Meeting Notes

Re: North Mason Street Open House

Project No.: 34826.002

Figure 1: Open Space Option Board with Comments

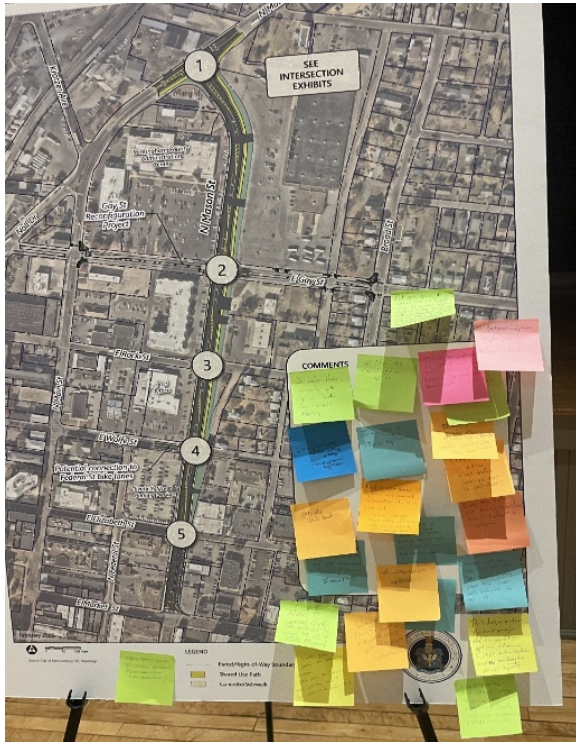
Open Space Option (24 Comments)
Put open space @ shared use on West side. Then shared use path could extend all the way to 33 and S. Mason, thus better connecting to downtown and JMU campus
Better option that provides actual lane
This is far preferable as it provides walking space and a shorter/safer crossing of the street for those on foot
I support this option
I like the OPEN space option
I prefer this separate path option – safer from cars!

I prefer this green space option. Prefer roundabouts to turn lanes.
I think crossing is easier when traffic lanes are not next to each other.
Like: Greenspace, safer walking/biking, driving lanes together
I LOVE this option
Love this and really love having sidewalks between Elizabeth & Market
Prefer open space option but concerned about viability with likely higher cost. Shorter crossings, more usable green space, SUP more valuable to users than bike lanes
Still like this best
Open space looks to offer better pedestrian options and intersections
PLEASE make it one lane each way with roundabouts (how it was last summer) – I second this!
Open space on east side makes more sense given existing fronting uses and residential neighborhood further east
Marked left turn lane is likely safer than TWLTL. May create some issues with entrances on east side
I like this option
This design makes the most sense for all transportation options, pedestrians, cyclists, automobiles and prioritizes most safety

What happens to SUP south of Wolfe St?
Need to connect shared use path all the way to 33 and South Mason!
Looks great. Safer for bikers and children. Also safer for drivers who are likely to have accidents at intersections
Would love to have a roundabout at 33/Mason intersection
Configuring the open space to allow for temporary shops like the summer demonstration

Figure 2: Wide Median Option Board with Comments

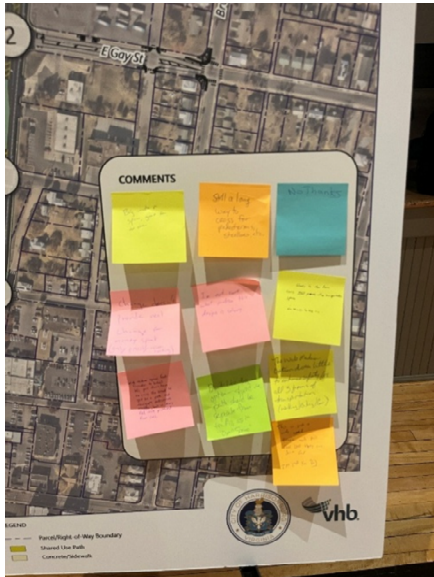
Wide Median Option (10 Comments)
This is just a wide road. People will still feel like they can drive fast. It's just so big.
The wide median option does little to enhance safety for all forms of transportation
Don't like this option – shared use path should be separate from traffic as in open space option
Wide option feels friendlier to bikes because you don't have to cross the street to get to a path and navigate pedestrian traffic, but it does feel more protected from cars
Doesn't provide real change for money spent (only possibly nicer looking)
I'm not sure what problem this design is solving
No thanks to this – needs to slow down cars AND provide transportation space
No thanks

Big waste of space, good for no one

Still a long way to cross for pedestrians, strollers, etc.

Figure 3: Existing Conditions Compared to Open Space and Wide Median Options Board with Comments

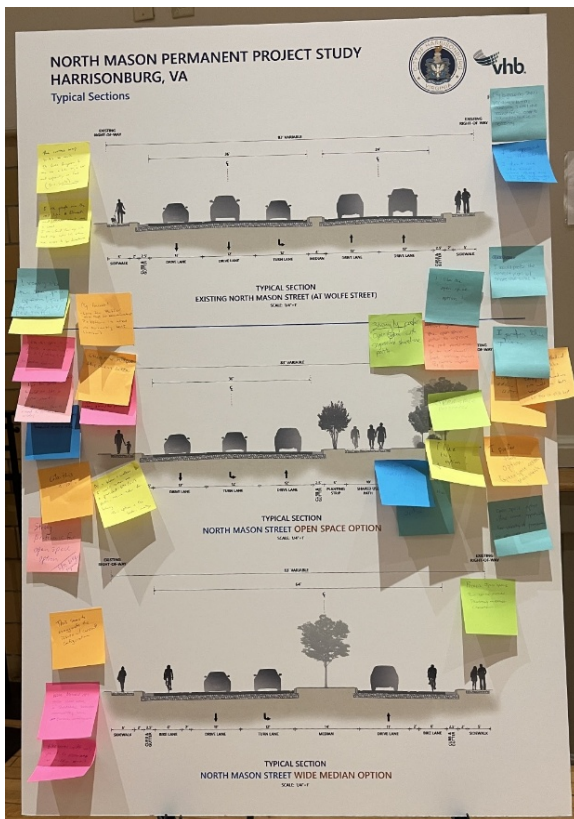
Existing (4 Comments)	Open Space (23 Comments)	Wide Median (3 Comments)
I am opposed to the change. I don't see the need when there are already sidewalks on both sides of the road.	I prefer this option	Prefer open space, but wide median probably an easier conversation
I would prefer the current plan with share used bike lane	I prefer the sheltered option for bikes and walkers. Ideally the shared use path would be both ways but this is still best.	Bike lanes with only paint to separate car traffic aren't preferred

<p>City is growing, JMU's population is also increasing. I feel like the need of traffic lanes to accommodate traffic is necessary</p>	<p>Like the open space option</p>	<p>Wide median opt still feels like a barrier between communities, will deter connectivity</p>
<p>I see people run the red light at Elizabeth and Mason about once a week. I am afraid for my life and my son's life when we cross to go downtown. The current set up sucks so much. It feels dangerous to me on a bike or in a car but especially on foot. (This sucks with an arrow pointing to Exisiting)</p>	<p>I like the open space option!</p>	
	<p>Thank you for the open space option to improve the ped experience. Love making Mason 2 lanes instead of 4.</p>	
	<p>Open space preferred</p>	
	<p>Strongly prefer "open space" with separated shared-use path</p>	
	<p>Open space option looks great</p>	
	<p>I like this option!</p>	
	<p>I like this option. Green space seems more usable.</p>

<p>I prefer the open space option.</p>	
	<p>Open space option offers more opportunity for variety of programming for open area</p>	
	<p>I really like the open space option! Feels safer for bike/ped traffic</p>	
	<p>Open space option!</p>

My favorite! Love the buffer, more room for beautification, the wide median option is what we currently have (similar)	
	Clear preference for this option. Like the potential for open space provides multiple turn options for pedestrians, traffic, etc	
	I like this option as it provides a usable space for kids, walkers, and bikes. The median does not.	
	I love this option. Would be like a linear park! Do the car lanes need to be that wide?	
	This option has more green space and seems more safe	
	As a biker and walker, I would rather see a protected bike/walk path. Much safer for biking. This option is best.	
	I like this a lot!	
	Strong preference for open space option. I like bike separation.	
	This seems to exaggerate the issues with current configuration

Figure 4: Open Space Board with Comments

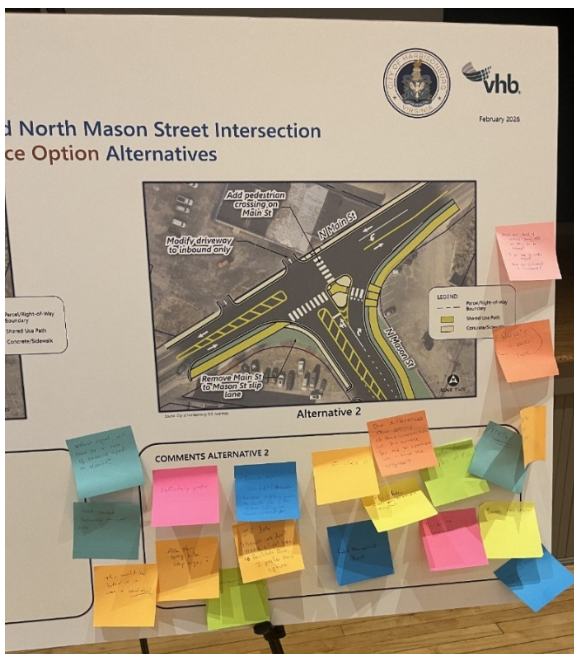
Alternative 1 (0 Comments)	Alternative 2 (20 Comments)
<u>No comments</u>	I like no light so vehicle traffic needs to pay more attention.
	Prefer this option
	By far the best option

I vote for this alt #2
	Like alternative 2 best
	This is better. More space for bike/ped throughout
	Pedestrian crossing allowed?
	If data shows we don't need a light here to facilitate flow, I prefer this option
	Are there going to be stop signs?
	This would be better if it were a roundabout
	Need marked crosswalk on west side
	Without signal, will there be a risk of excessive speed on Main St?
	Definitely prefer
	Remove signal. Use RRFB @ crosswalk. Consider shifting walk to south side with median refuge to reduce conflict points
	I like it
	The differences between options at this intersection are too subtle for me to comment on. I trust the engineers.
	Prefer
	Prefer this subtle change

How will speed of vehicles going N/S on Main st be reduced? I do like no traffic signal. Have you considered a roundabout?
	(Rose's is over here)

Figure 5: Wide Median Option Board with Comments

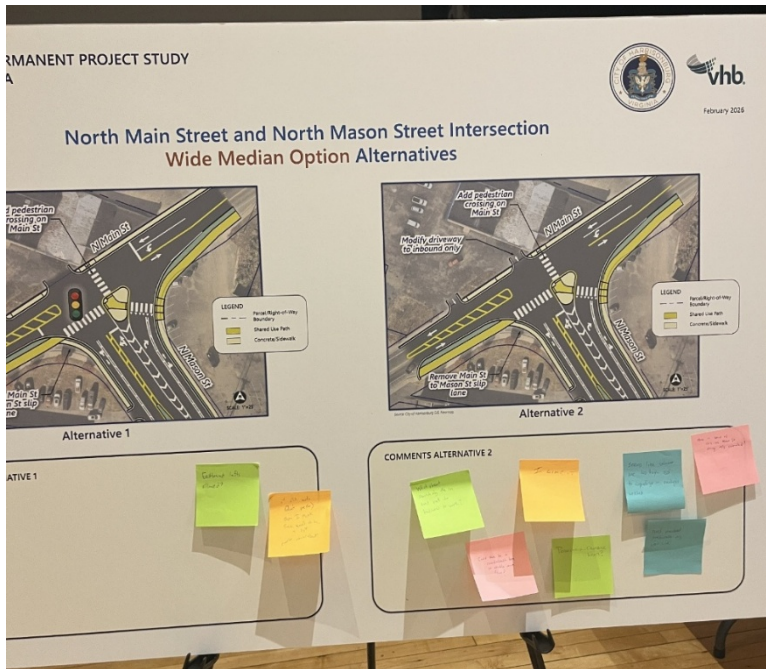
Alternative 1 (2 Comments)	Alternative 2 (7 Comments)
Eastbound lefts allowed?	How is speed of cars on Main St going N/S controlled?
It is wide (don't prefer) then I think there needs to be a light. Prefer roundabout	Need marked crosswalk on west side
	Seems like volume are too high not to signalize – analysis needed
	Pedestrian crossing light?
	What about switching the in and out to business to north?

I like it
	Could there be a roundabout here to enable more flow?

Figure 6: Open Space and Wide Median Option Board with Comments

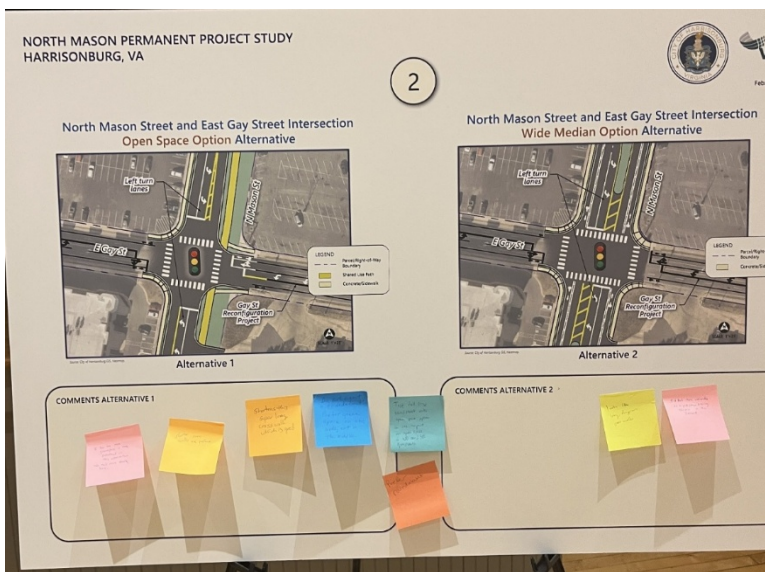
Alternative 1 (4 Comments)
I like the more greenspace + tree potential in this alternative. We need more shade here.
Shorter crosswalks are preferred
Shortens this super long crosswalk which is good
Do not want a roundabout! Prefer green space on one side, not in the middle

Alternative 2 (4 Comments)
Prefer roundabout
Looks like long dangerous crosswalks
Test full size roundabout with open space option to see impact on open space in NE and SE quadrants
I feel more vulnerable as a pedestrian crossing Mason in this scenario

Figure 7: Open Space Option, Roundabout Option Board with Comments

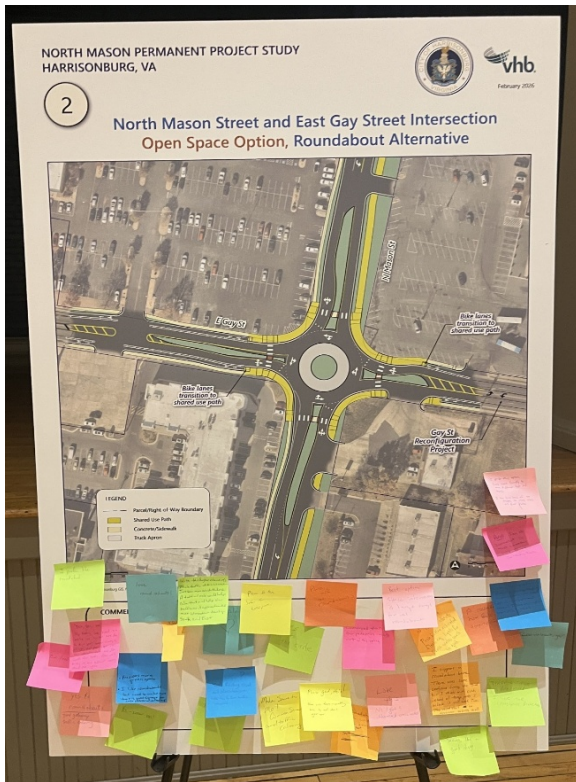
Roundabout Alternative (30 Comments)
Yes! I support this!
Provides more green space. I like the roundabouts but need to make sure there is good signage for safe pedestrian crossing
Prefer
Yes! Existing signal and interaction are over-built for traffic volumes.
Make sense to me! Commonsense and traffic calming
The roundabouts were the highlight of the previous project

Yes please (heart drawing)
Yes
Yes to the circle
Please god, this! Slow cars down – walking here is not ideal right now
Love this! No light & shortened crosswalks
I support a roundabout here. There was some confusion during the trial, but I think with curbs instead of temp posts I believe it will work fine. The roundabout on the Reservoir works well.
Seems like a good design.
Concerned about how pedestrian crossings work with this option
Public art at roundabout?
Please do this. Safer for everyone.
With the higher volume of vehicle traffic at this intersection I've seen more accidents here. A traffic circle would help slow traffic as it approaches the next intersection traveling South and East
Love roundabouts!
Best option since intersection is large enough for real roundabout
I'm a fan of roundabouts. Push button activated flashing lights for cross walks would be good
Traffic circle preferred. I like the crosswalk placement.

Roundabout, yes!!
A roundabout here feels very appropriate
I prefer this option. Feels more friendly to more different type of users. I like less lanes of car traffic to cross while on foot + bike
HUGE fan of roundabout in this location. Worked so well in trial run.

Crossing this intersection on foot while the temporary traffic circle was present was so much faster and pleasant. I love this option when driving as well

I prefer the roundabout

Yes, yes, yes! My family was involved in a terrible car accident here due to high speed – someone running a red light and poor sight lines. This intersection needs this to slow traffic down

This looks good!

Yes to roundabouts! Good gateway traffic calming

Figure 8: Open Space Option Board with Comments

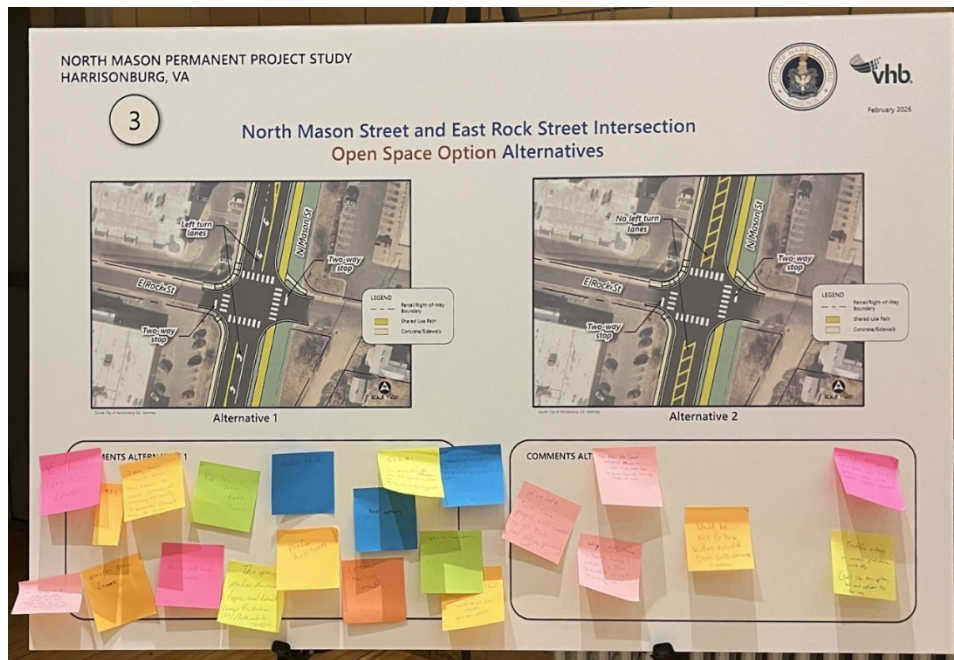
Alternative 1 (16 Comments)	Alternative 2 (6 Comments)
Prefer turn lanes	If not left turn then people will choose to go through post office parking lot
It's going to be harder to walk across this alternative with turn lanes. Could there be some sort of signal for pedestrians & bikes to cross?	This feels safer / easier to cross Mason on foot and on bike due to fewer lanes of vehicle traffic to cross
Yes to left turn lane	Why not have a turn lane? What is the benefit to not having one?

Yes	Would be nice to have bottom activated cross walk warning lights
Two way stop makes sense. Still allows for some control, or slowing of movement, to provide space & time to turn	I like this option as there could be a pedestrian (unknown word) in the center – please consider
Yes to left turn lanes	Traffic calming & increase pedestrian visibility (Don't like this option, but want options to slow cars)
This option makes the most logic and doesn't cause frustration with automobile traffic	
Yes to left turn lanes	
Prefer this	
Prefer turn lanes	
I prefer turning lanes	
Best option	
This is a much more reasonable of a crossing distance when on foot compared to the widened option	
Yes to this. Less road surface, more full separation from cars and allowing left turn is good.	
Yes to turn lanes	
This should be a roundabout – otherwise might as well allow left turn? Not a smart option

Figure 10: Open Space Option Board with Comments

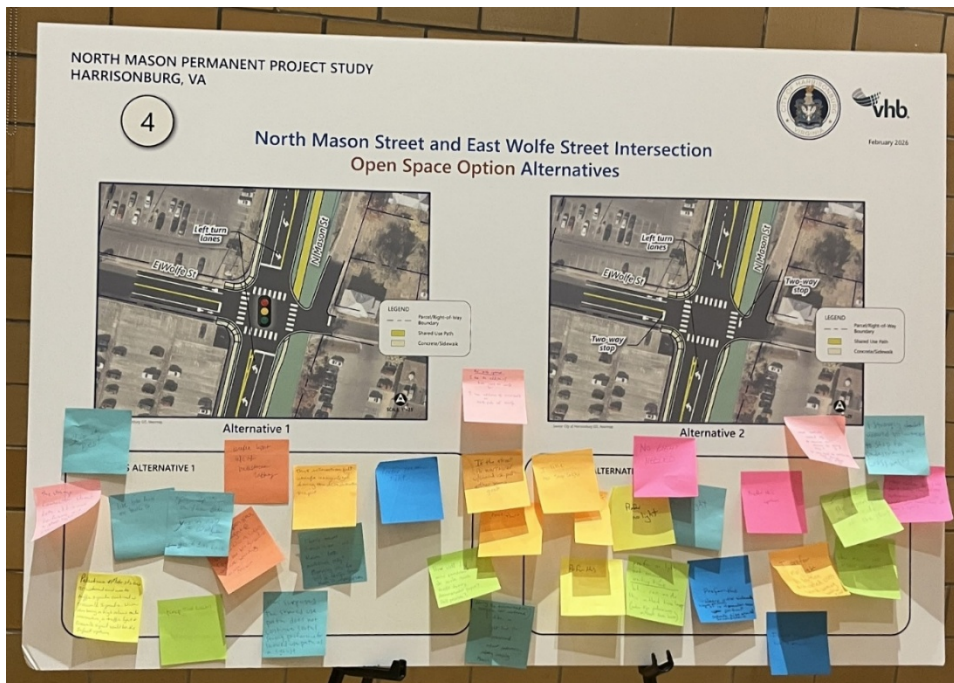
Alternative 1 (17 Comments)	Alternative 2 (16 Comments)
(During the demonstration everyone was confused) I like no light, but I'm concerned about pedestrian safety when crossing Mason	What controls speed of vehicles on Mason St going N/S? It was hard to cross Mason here during demo project with no light
Roundabout?	Prefer this option
If the street is narrower with shared use path either seems good	Prefer this. Where is the sidewalk in lower portion? Or is it smaller than upper portion? Sidewalk size should be consistent.

<p><u>For both options</u>. I like the addition of the bike lanes on Wolfe St. I like addition of crosswalk on Northside of Wolfe</p>	<p>Prefer no light</p>
<p>How well did mini roundabout do with truck traffic during demonstration project? Still possible?</p>	<p>Prefer no light not necessarily waiting time – but...can we do this without turn lanes? Safer for pedestrians without turn lanes.</p>
<p>Keep the light</p>	<p>Prefer this</p>
<p>I'm surprised the shared use path does not continue south! Strong preference for shared use path as a cyclist</p>	<p>Prefer no light</p>
<p>Clarify travel direction on "Old Mason" Better roundabout only? Emerging vehicles will be farther from Mason St. intersection</p>	<p>Prefer no light</p>
<p>This is best</p>	<p>I like no stop sign</p>
<p>The strange connector street does add some confusion and a stop light is clear</p>	<p>No light needed</p>
<p>Open space on the side. Yes, to light @ Wolfe. Yes, to bike lane.</p>	<p>I strongly doubt I would volunteer to stop for pedestrians at crosswalks</p>

<p>I like bike lanes on Wolfe St</p>	<p>I like this option. Please consider site lines for visibility turning left onto North Mason. Is there a way to slow traffic here other than a light?</p>
<p>Prefer light because of pedestrian safety</p>	<p>I like the open space on the side of the street</p>
<p>Pedestrian & motorists are accustomed and use to traffic signals combined with crosswalk signals. With this being a high volume auto intersection, a traffic light and crosswalk signal would be the safest option</p>	<p>I prefer no light. A button activated cross walk warning would be great.</p>
<p>I prefer open space and a light @ Wolfe. Without a light, I can see N&S bound drivers speeding down Mason</p>	<p>I think no light here is reasonable</p>
<p>This intersection felt unsafe (unreadable word) during the demonstration project</p>	<p>I prefer no light. How might that affect pedestrians?</p>

Prefer the traffic light	
--------------------------	--

Figure 11: Wide Median Option Board with Comments

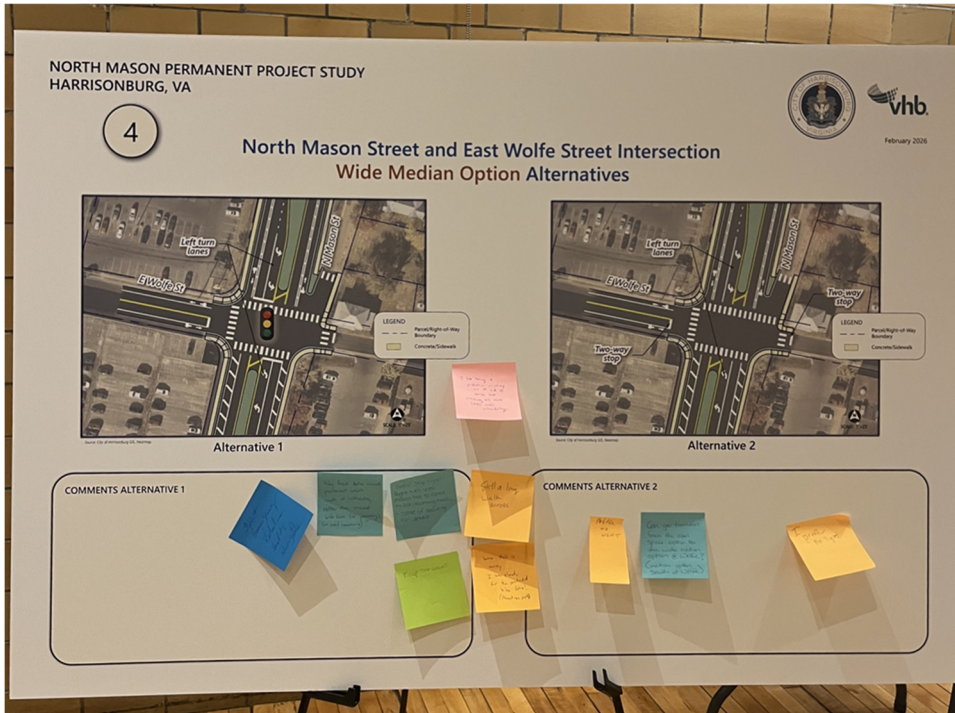
Alternative 1 (7 Comments)	Alternative 2 (3 Comments)
Wow this is messy. I was already for the protected bike lane! (Shared path)	Prefer no light
Still a long walk across	I prefer no light
I like having a pedestrian crossing on N. Side of Wolfe but crossing all those lanes looks intimidating	Can you transition from the open space option to the wide median option @ Wolfe? (Median option South of Wolfe)
Keep the light

Prefer stop light. Right turn onto Mason has to come to see oncoming traffic	
Why leave extra unused pavement width south of intersection rather than marked bike lane (or parking) (or road narrowing)?	
(Unreadable word) emergency vehicles hard to navigate
